### CONDITIONS OF APPROVAL:

## **Engineering - Final Plat Checklist**

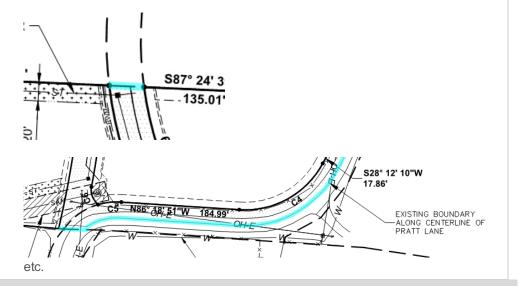
lance.fittro@franklintn.gov Applicant shall show the lengths of the boundaries of the subdivision, measured to the nearest foot and decimals, with calls. This is to include the boundaries of the ROW being dedicated along the centerline of Pratt Lane, and at the northern and southern ends of the Reams Fleming Blvd ROW dedication.

## 41138.02 V-Survey Plat - Sealed.pdf

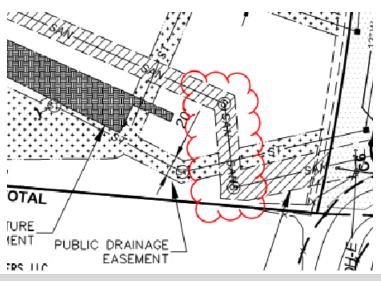
josh.king@franklintn.gov Applicant shall ensure future buildings and development on these parcels will require additional final plats to record required easements and/or improvements. Comment to stay on as a Condition of Approval
